# NORTH BRANCH

**PLANNING COMMISSION  
REGULAR AGENDA  
TUESDAY, JULY 1, 2025 @ 6:30 PM  
CITY HALL, 6408 ELM STREET, NORTH  
BRANCH, MN 55056**

MAIN STREET APARTMENTS  
 OWNER: TOMMY FOSTER  
 1275 WEST 4TH ST, RUSH CITY, MN

FRONT ELEVATION  
SCALE: 1/4" = 1' (1/2 SCALE ON 11X17)

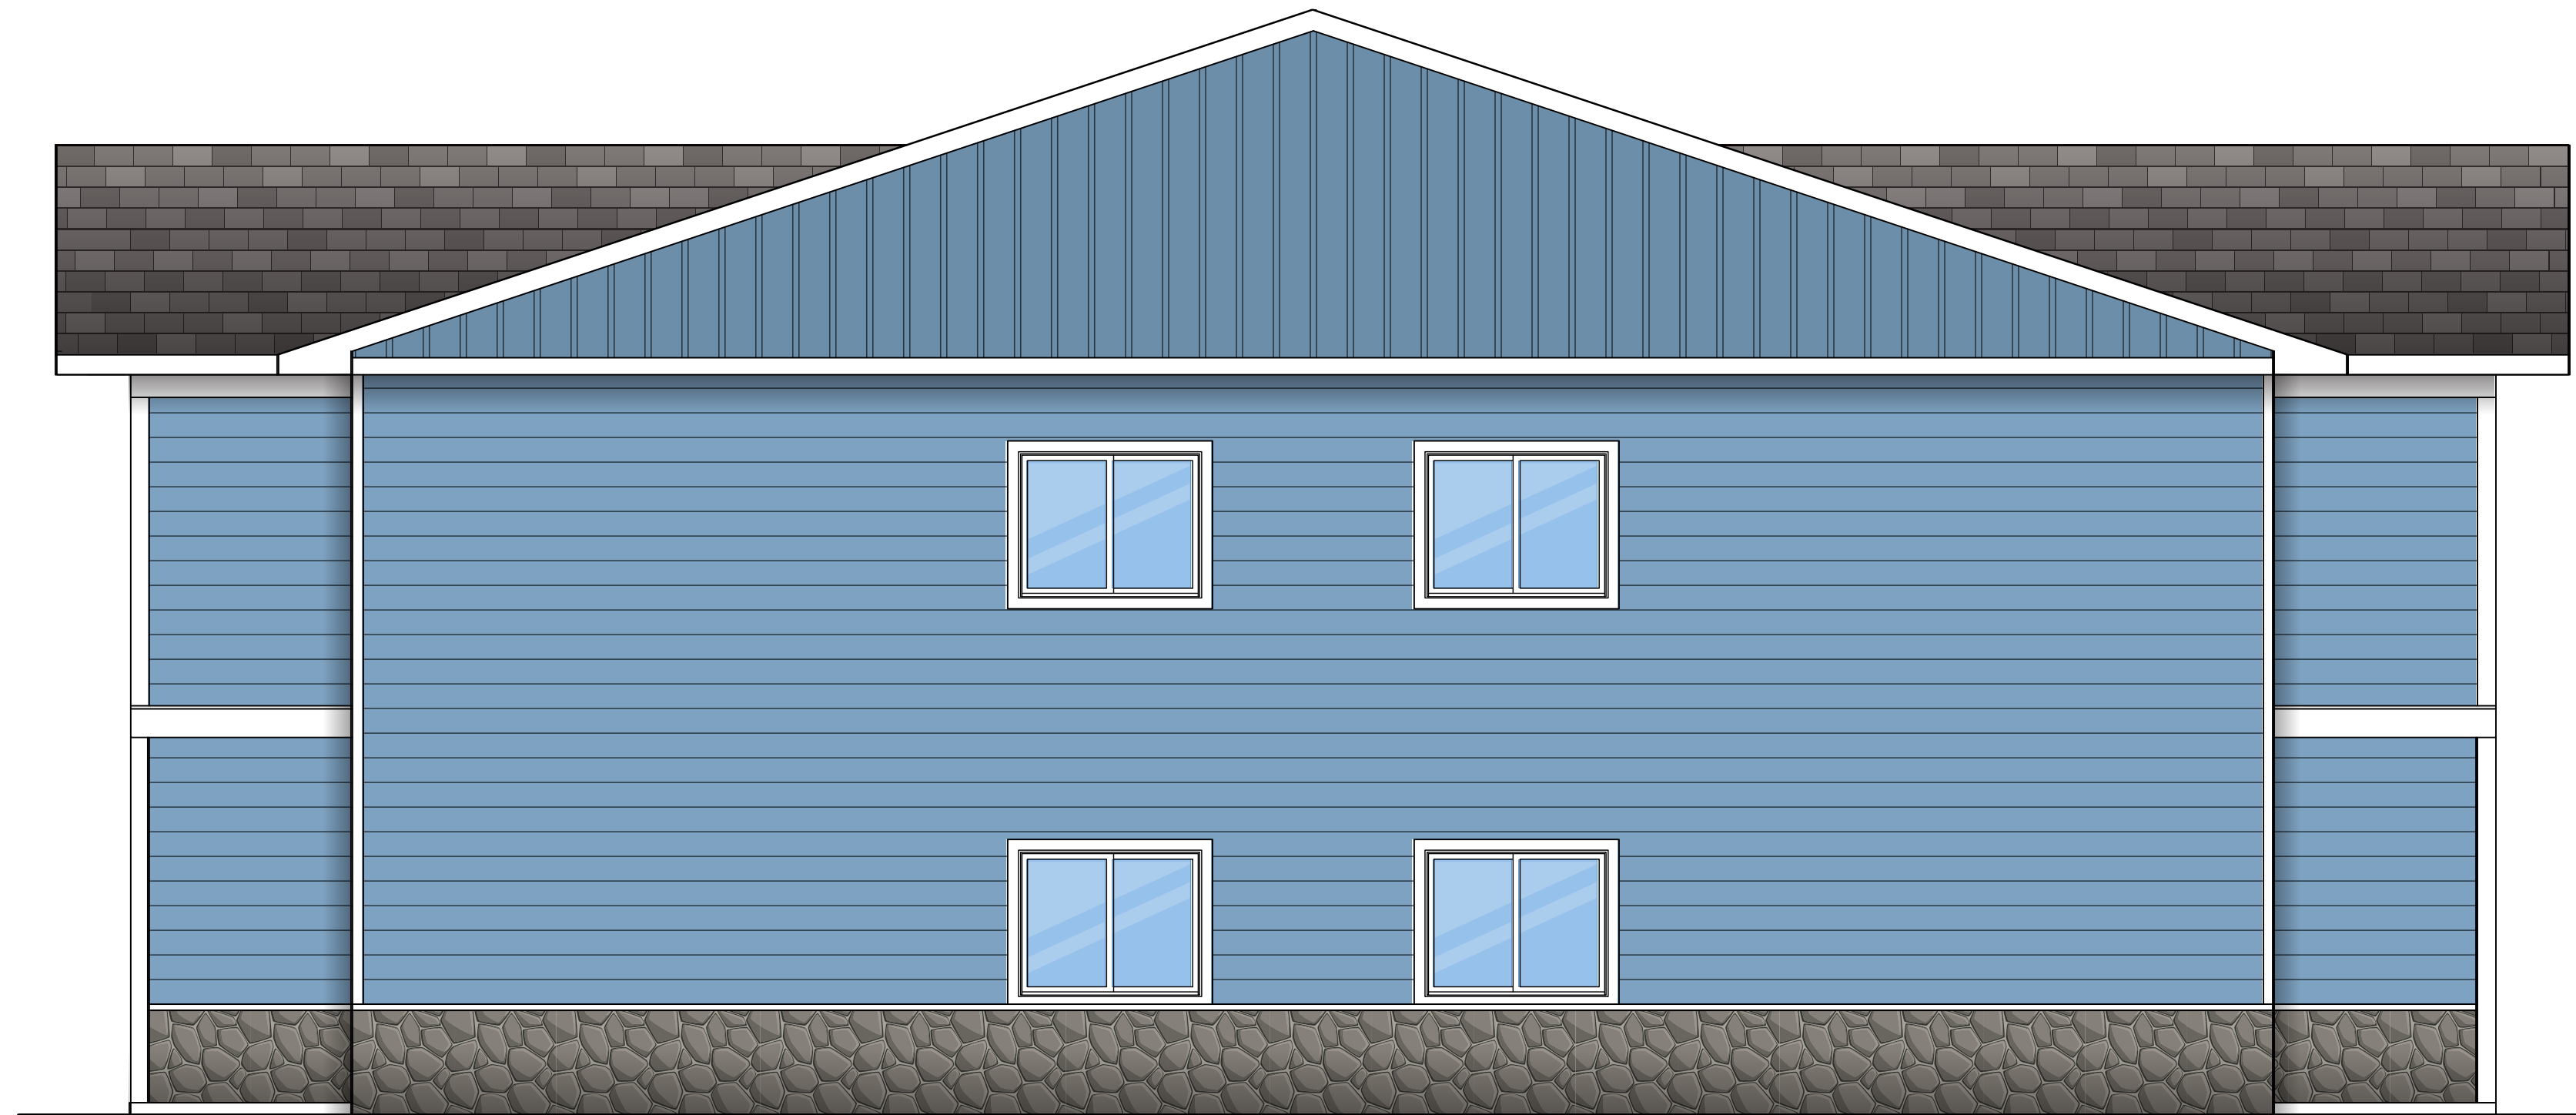
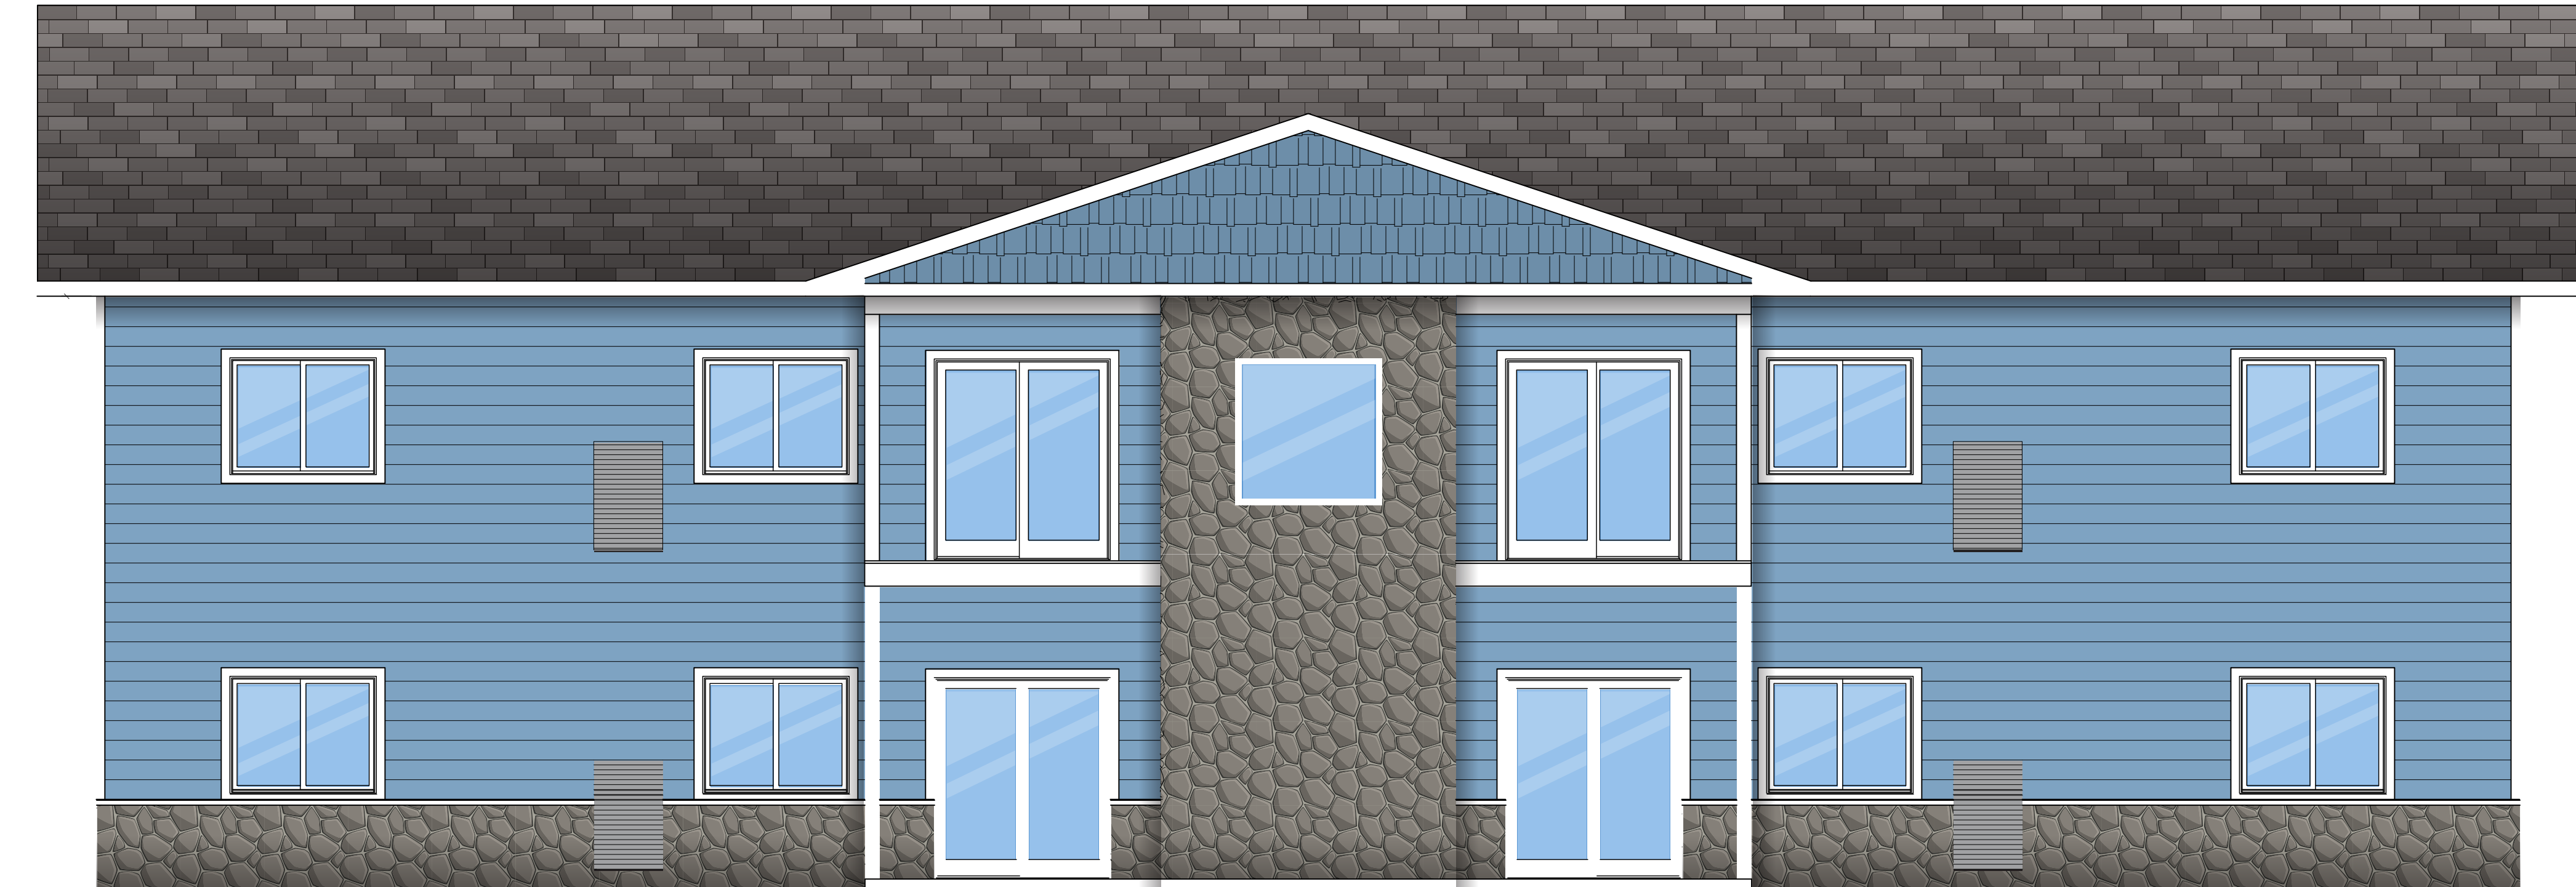
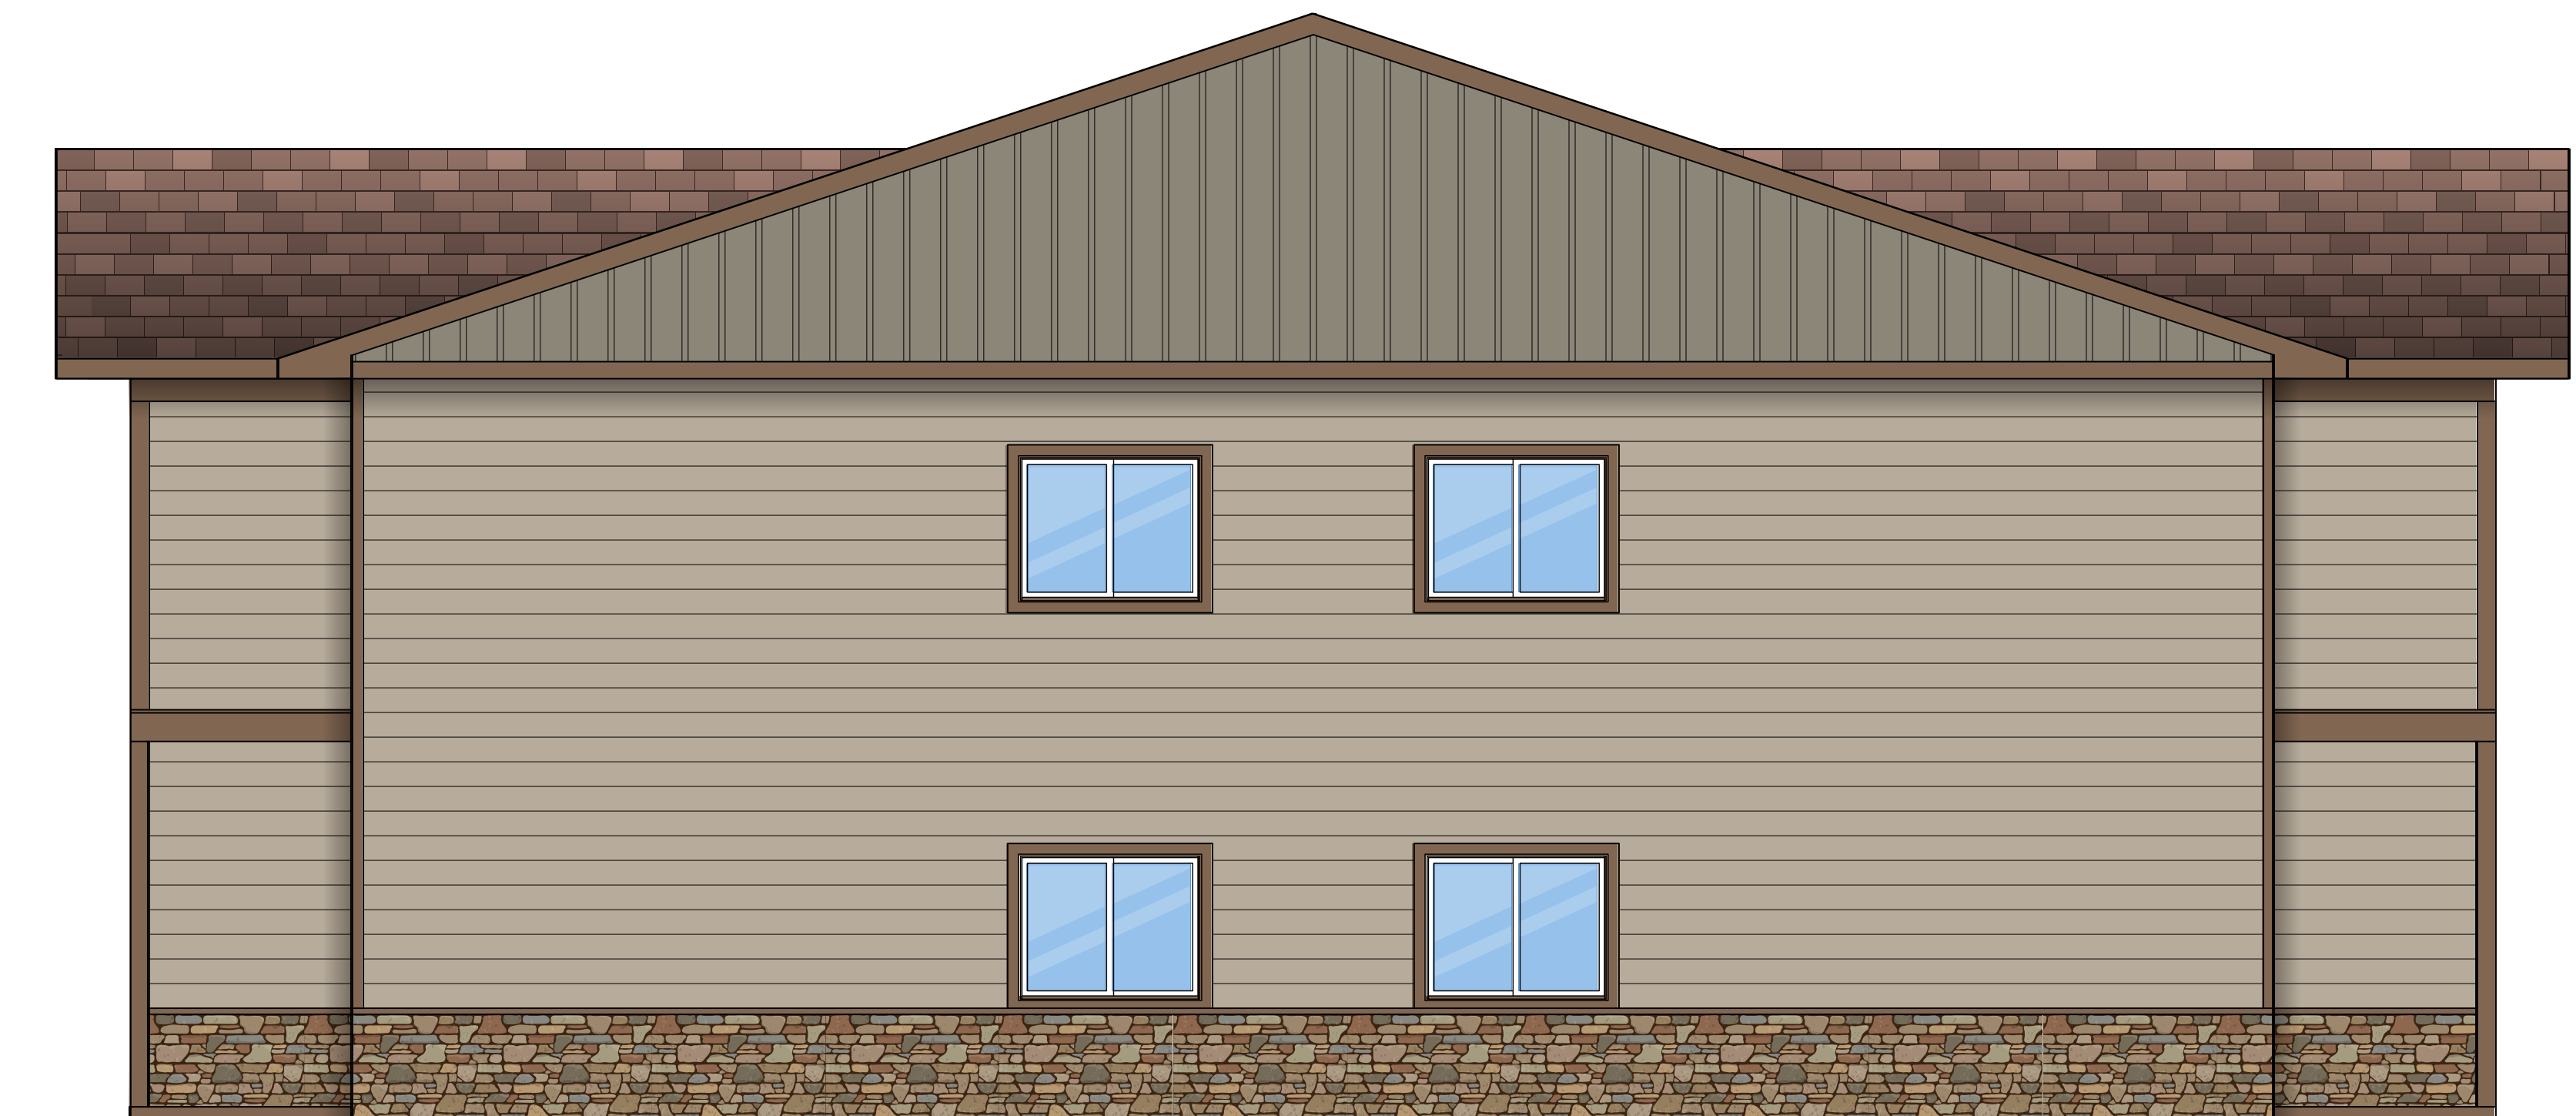
The ordinance requires building elevations with type and color of building materials, typical floor plans, dimensions of all structures and location of exterior buildings and equipment. The site is located in Zone 1 which requires that “Structures must provide a cohesive architectural appearance reflecting its functional purpose and must be composed of at least 65% Class I materials and not more than 35% Class II materials. Class I materials consist of brick, natural stone, glass curtain wall, copper or other comparable materials. Class II includes concrete block, precast concrete panels, masonry stucco, fiber-cement exterior siding, EFIS, smooth and scored block, and other similar materials.

In some instances, there could be some recognition other project attributes which would allow some reduction in the exterior materials requirements. However, in this instance the landscape plan and the site design do not provide any reason to vary from the current materials standards. As noted previously, this is a high visibility site both due to its location and lack of topography and the city is interested in having a project that sets the tone for future development and redevelopment in the downtown area. The lower quality building materials vary greatly from the ordinance criteria, and staff does not support the plan as proposed.

The developer has provided a revised landscaping plan to address screening along the east side of the site. along with revised building and architectural plans to meet the city design standards.
